SUPPLEMENTAL STATEMENT OF FACTS

BSA Calendar No:	2019-94-A
Premises:	36 West 66th Street, a/k/a 50 West 66th Street, Manhattan Block 1118, Lot 45 ("the Parcel")
Determination Challenged:	Issuance of Permit No. 121190200-01-NB ("the Permit")

EXHIBIT DRAWING NO: 17 DEPARTMENT OF BUILDINGS ORIGINAL FILED DRAWING EXISTING MECHANICAL EQUIPMENT DIAGRAM 17TH FLOOR (NO CHANGES TO MECHANICAL LAYOUT) 11-06-2019

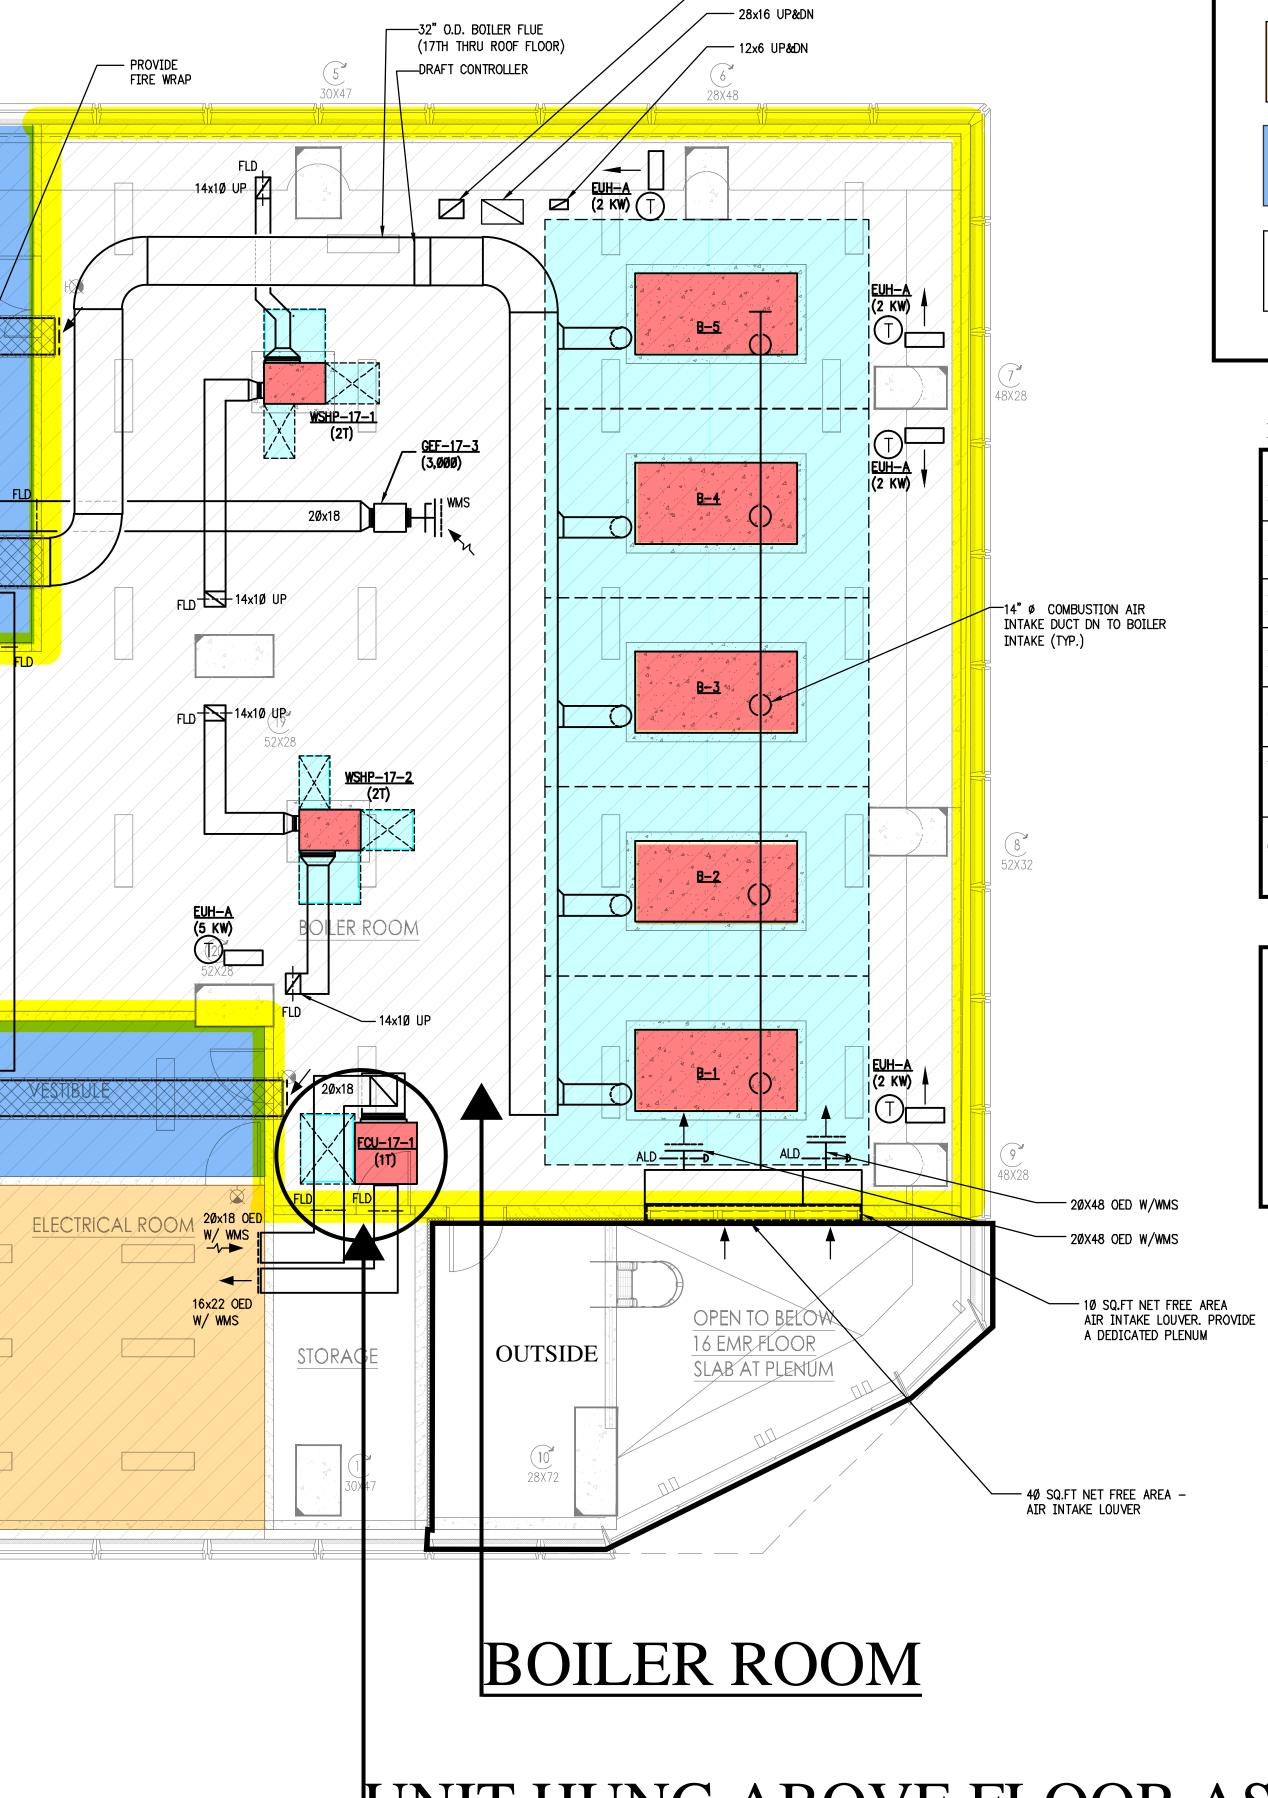
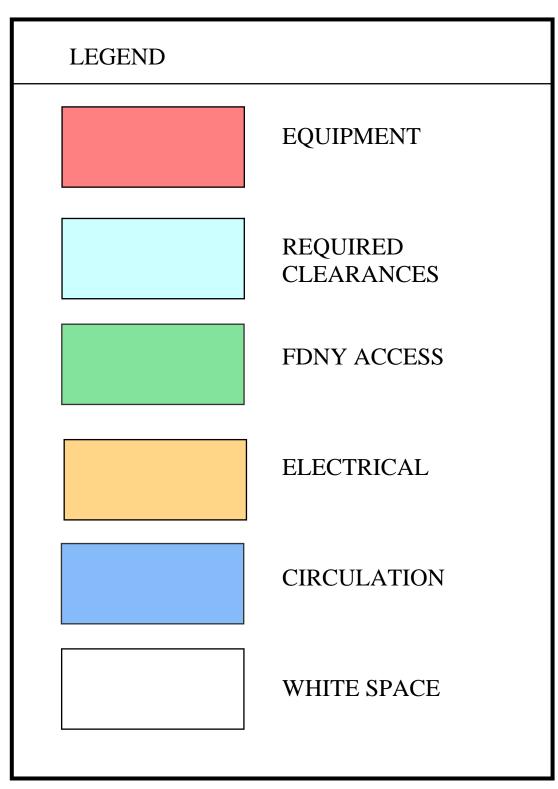
In particular, in the example of the 17th floor, Mr. Ambrosino identified two instances of close to 4,297 SF in FAR deductions taken for two pieces of equipment covering, together with access space, 1,039 SF, which results in an excessive deduction of 3,257 SF. This translates into anywhere between \$16,290,000.00 and \$32,580,000.00 in illicit sales through violation of floor area limitations. (See attached Exhibit that identifies the subject areas on the 17th floor plan).

Specifically, the eastside boiler room is 3,289 SF and contains three heat pumps, one of which is hung and takes no floor space. There are five boilers. The total area of all the equipment and service areas in this room is 1,059 SF: 97 SF for the two heat pumps on the floor and 962 SF for the boilers. As already shown on this drawing, the other two heat pumps could be hung or moved so as not to artificially increase the MER deduction. This leaves 2,327 SF of unused floor area. The design employs a 32 % use factor. And with a ceiling height of 60 feet. — the owner's

The second example is the MER between columns 12 and 14 and is 1,008 SF. The room contains one heat pump and 2 tanks. The total area of the equipment and service areas is 77 SF. There is no justification in the record for awarding a 1,300% deduction of mechanical space, or 930 SF, for 77 SF of equipment footprint and 1 SF of ductwork.

17TH FLOOR AREA CALCULATIONS		
MECHANICAL EQUIPMENT	412.2 SF	
REQUIRED CLEARANCES	1,308 SF	
FDNY ACCESS	563 SF	
ELECTRICAL	372 SF	
CIRCULATION	1,171 SF	
WHITE SPACE	6,418.8 SF	
TOTAL FLOOR AREA	10,216 SF

412.2 + 1,308 + 372 = 2,092.2 SF

2,092.2 / 10,216 = 20%
